3.2 Bloom Street

4.0 Design Changes

4.1 List of Design Changes

4.2 Space planning and compliancy

Bloom Street. Roof plan

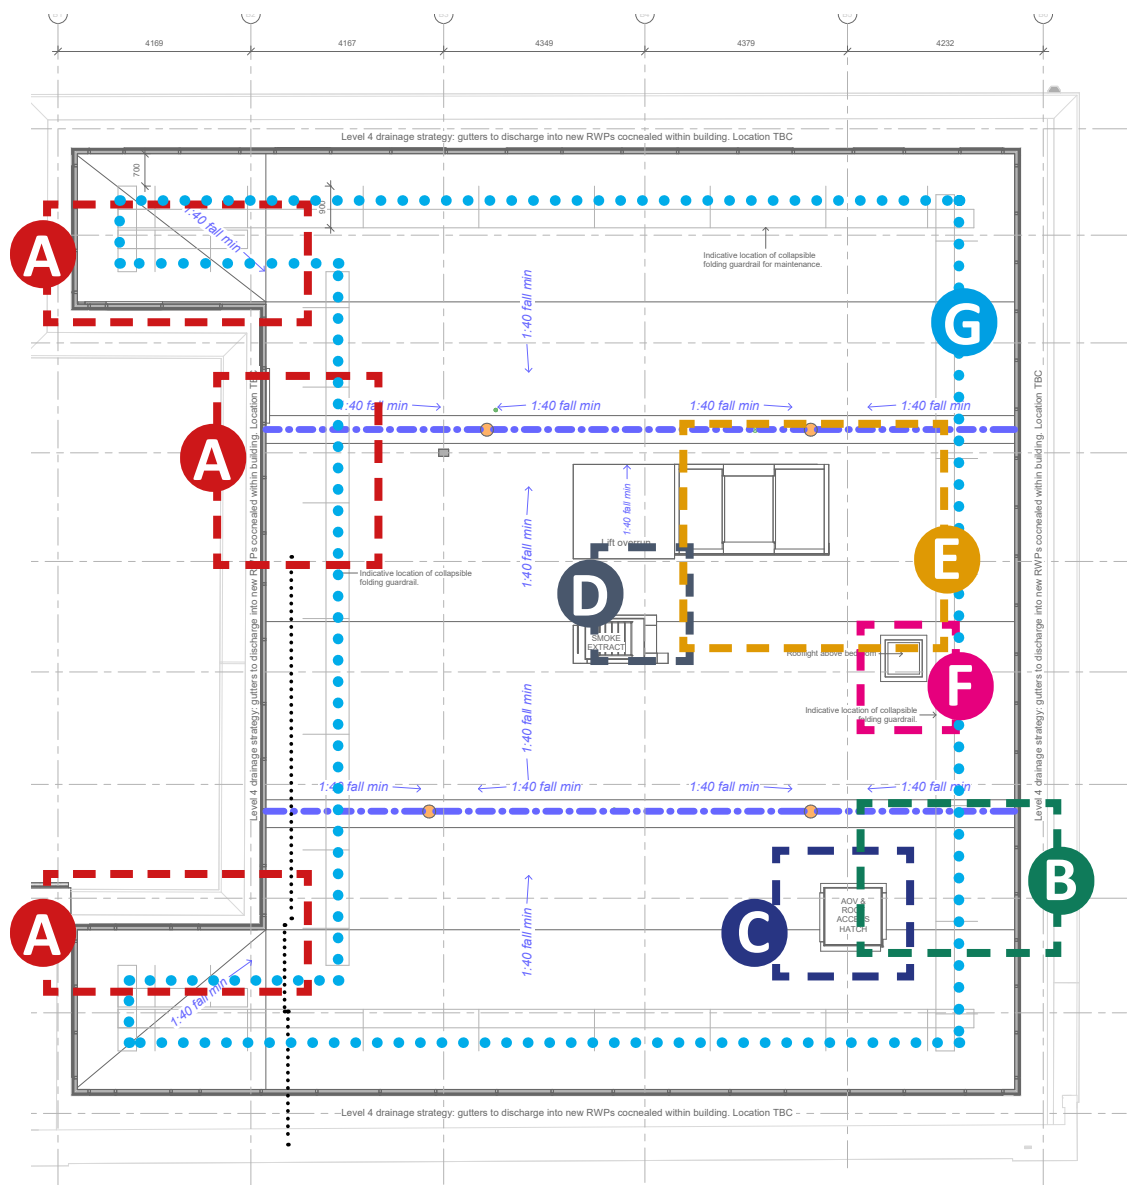
- Apartment layout: Improved efficiency and open plan arrangement where possible.
- New structural columns: Relocation of steel H columns supporting new floor above following structural proposal review.

Roof area extended: Required following removal of terraces from level below.

Rooflight above stair removed: Natural lighting from glazed curtain walling.

A.O.V Hatch: Approved location above lobby not functional. Proposed to be relocated above stairs.

A.O.V Hatch: No longer required. Proposed to be removed.

Plants: Ventilation strategy revised. Extent of plants located to the roof significantly reduced. Covering screen no longer required.

Rooflight: additional rooflight for bedroom

Maintenance: collapsible guardrail system for roof maintenance and window cleaning

Mindel House. Lower Ground Floor

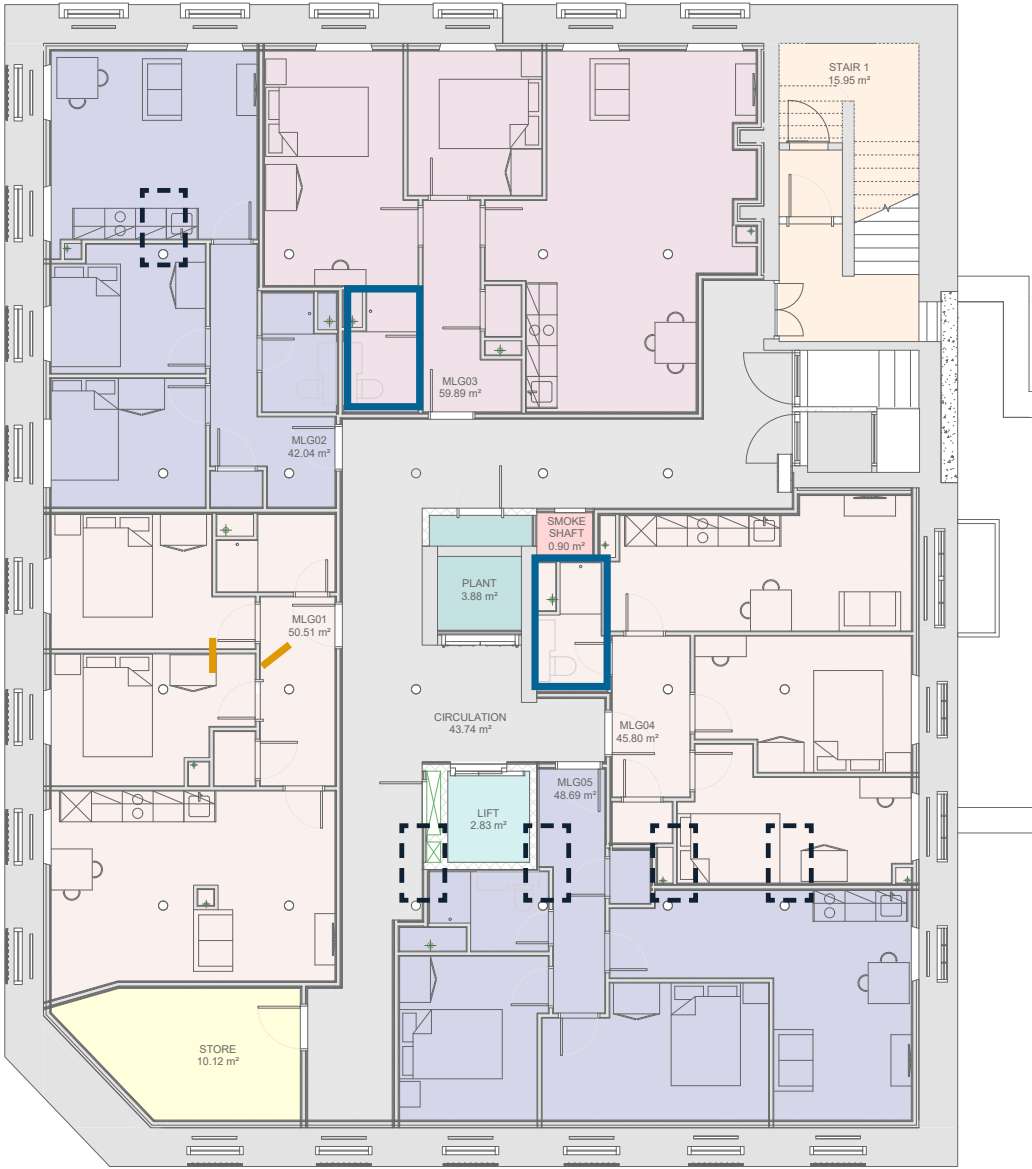
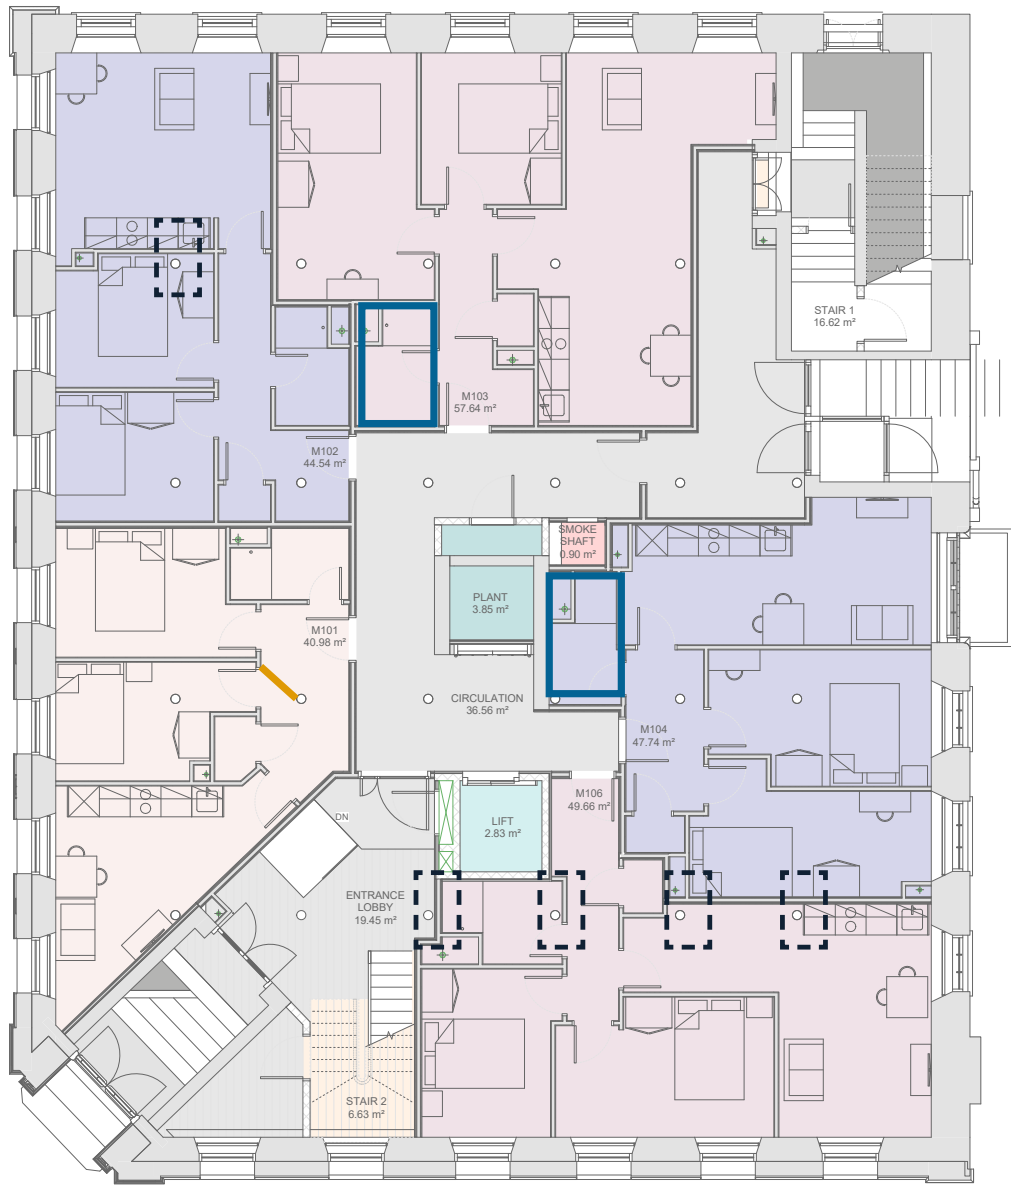
Clear width non compliant (less than 850mm)

Bathroom non compliant (typically too narrow)

Column capital clashing with wall

OPEN PLAN ARRANGEMENT
INVERTED KITCHEN/LIVING WITH BEDROOM LOCATION
REDUCED CIRCULATION
PARTITIONS NOT CLASHING WITH COLUMN CAPITALS
EXPOSED COLUMNS AND CAPITALS

OPEN PLAN ARRANGEMENT
IMPROVED LOUNGE AREA WITH DEDICATED KITCHEN CORNER
OPTIMIZED LAYOUT

OPEN PLAN ARRANGEMENT
INVERTED KITCHEN/LIVING WITH BEDROOM LOCATION
PARTITIONS NOT CLASHING WITH COLUMN CAPITALS
EXPOSED COLUMNS AND CAPITALS

Mindel House. Upper Ground Floor

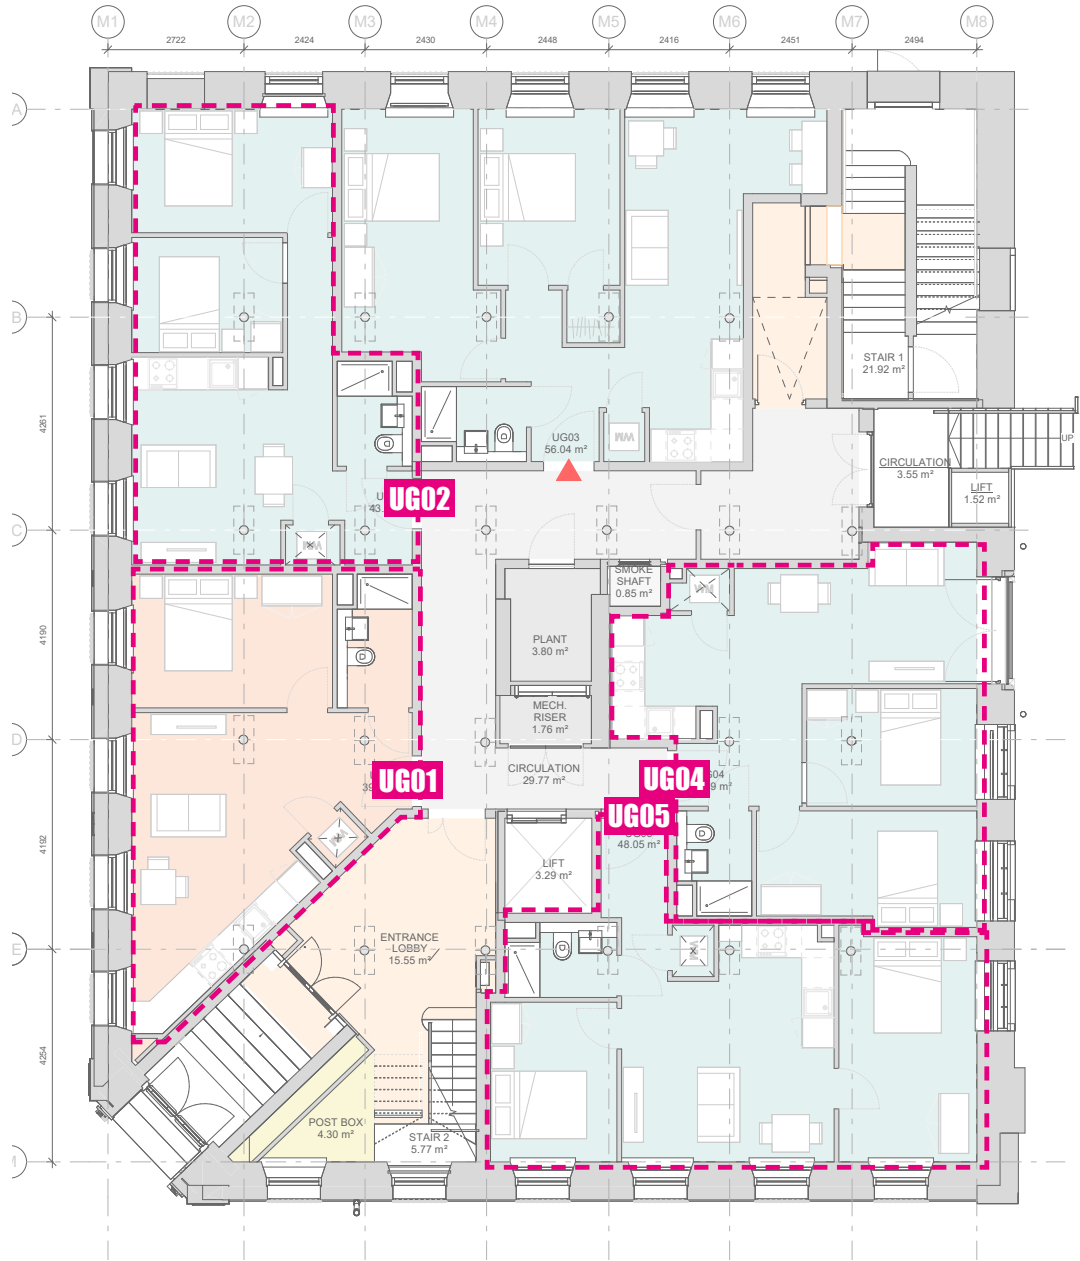
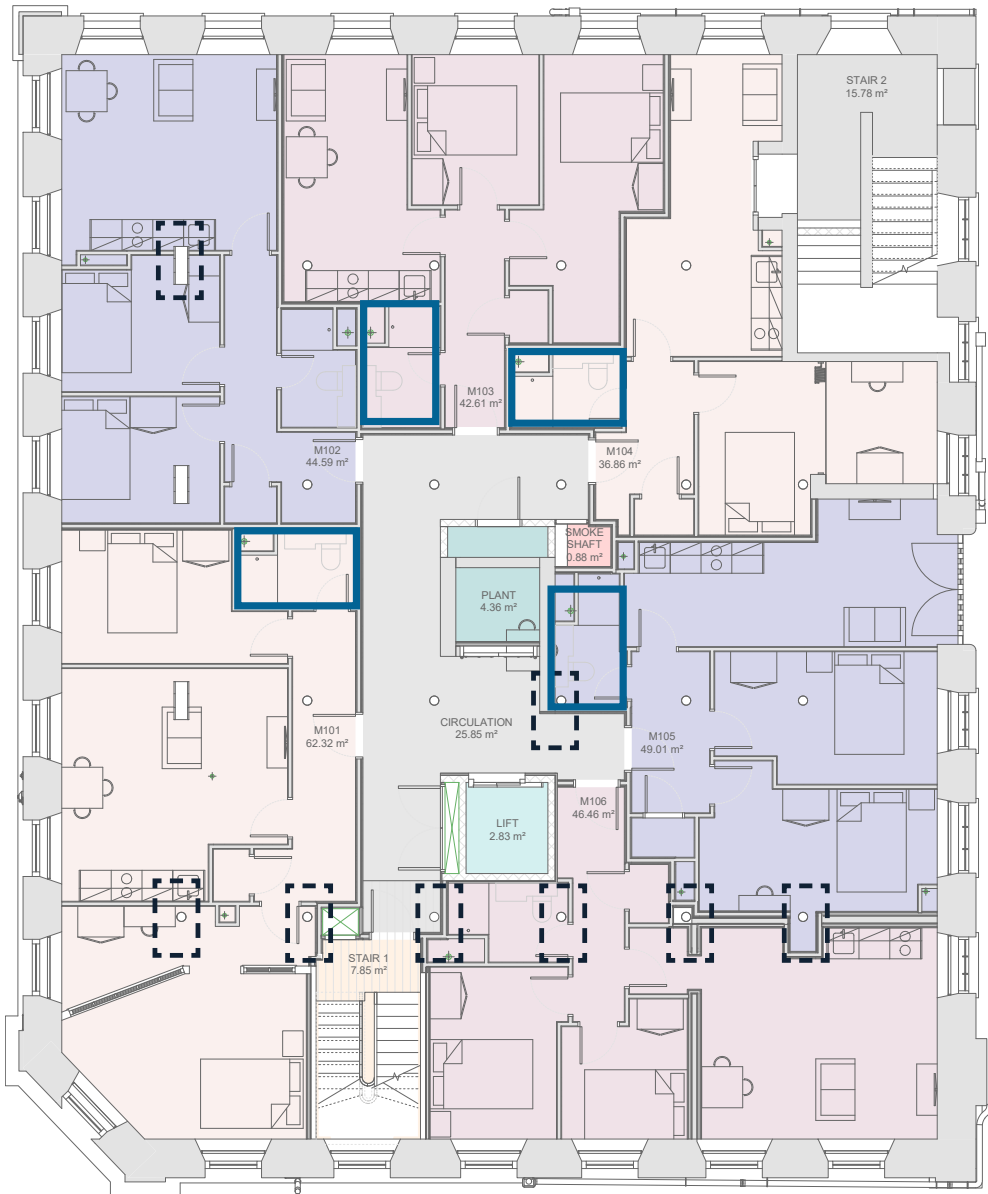
- Clear width non compliant (less than 850mm)
- Bathroom non compliant (typically too narrow)
- Column capital clashing with wall
- Layout Change

- UG01** OPEN PLAN ARRANGEMENT
IMPROVED KITCHEN/LIVING
REDUCED FROM 2 TO 1 BEDROOM
EXPOSED COLUMNS IN LIVINGROOM
- UG02** OPEN PLAN ARRANGEMENT
INVERTED KITCHEN/LIVING WITH BEDROOM LOCATION
REDUCED CIRCULATION
PARTITIONS NOT CLASHING WITH COLUMN CAPITALS
EXPOSED COLUMNS AND CAPITALS
- UG04** OPEN PLAN ARRANGEMENT
IMPROVED LOUNGE AREA WITH DEDICATED KITCHEN CORNER
OPTIMIZED LAYOUT
- UG05** OPEN PLAN ARRANGEMENT
INVERTED KITCHEN/LIVING WITH BEDROOM LOCATION
PARTITIONS NOT CLASHING WITH COLUMN CAPITALS
EXPOSED COLUMNS AND CAPITALS

Mindel House. First Floor

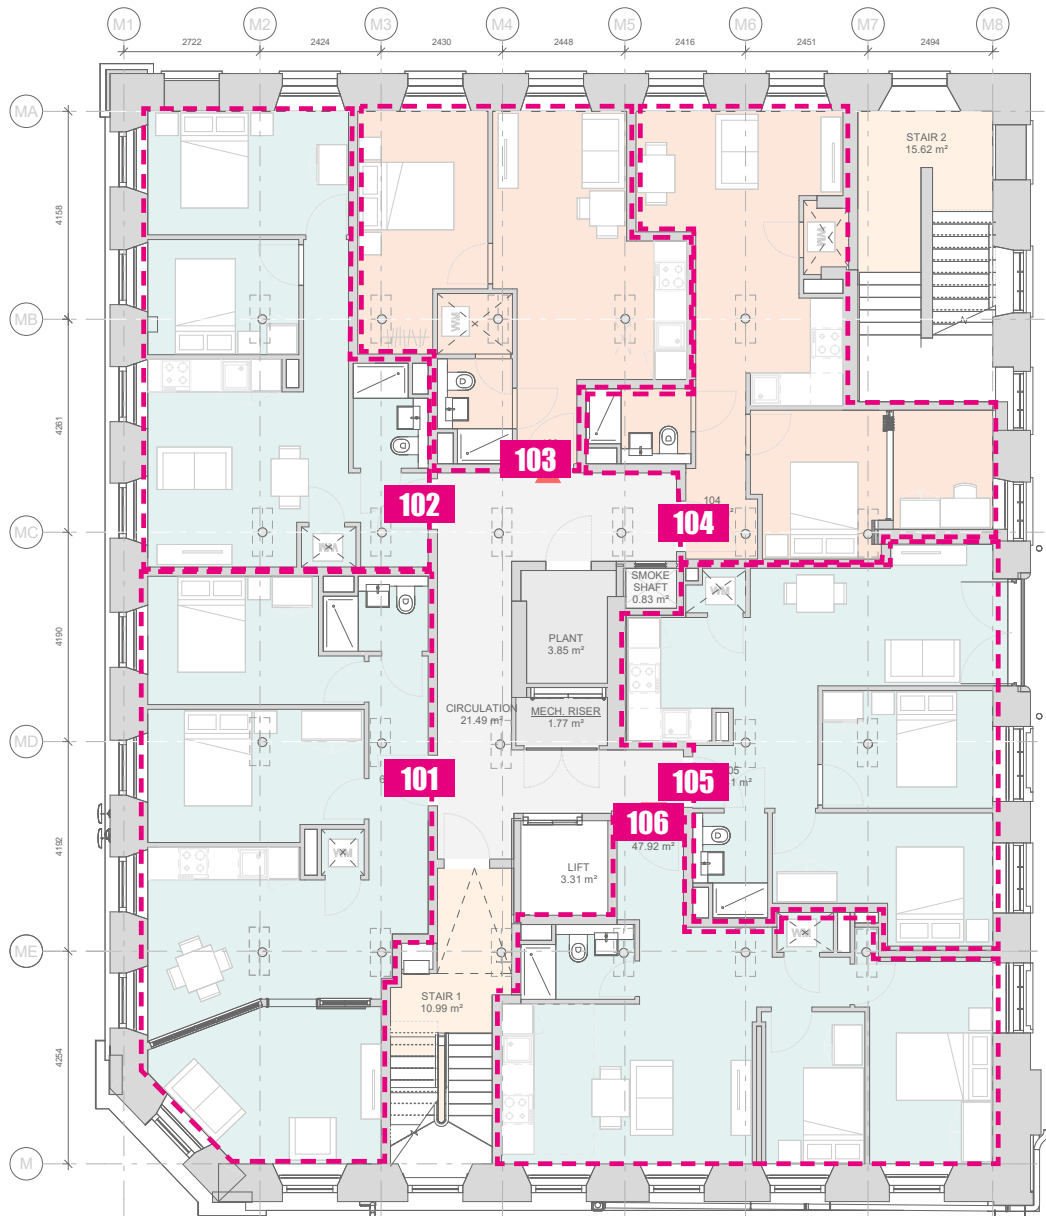
- Clear width non compliant (less than 850mm)
- Bathroom non compliant (typically too narrow)
- Column capital clashing with wall
- Layout Change

- 101 INVERTED KITCHEN/LIVING WITH BEDROOM LOCATION
EXISTING GLAZED PARTITION DIVIDING KITCHEN/LIVING
EXPOSED COLUMNS AND CAPITALS
PARTITIONS NOT CLASHING WITH COLUMN CAPITALS
- 102 OPEN PLAN ARRANGEMENT
INVERTED KITCHEN/LIVING WITH BEDROOM LOCATION
- 106 REDUCED CIRCULATION
- 105 PARTITIONS NOT CLASHING WITH COLUMN CAPITALS
EXPOSED COLUMNS AND CAPITALS
- 103 LAYOUT REVISED TO IMPROVE ADJACENT APARTMENT
REDUCED FROM 2 TO 1 BEDROOM
OPEN PLAN ARRANGEMENT
- 104 LAYOUT REVISED TO IMPROVE LIVING SPACE
EXPOSED COLUMNS AND CAPITALS
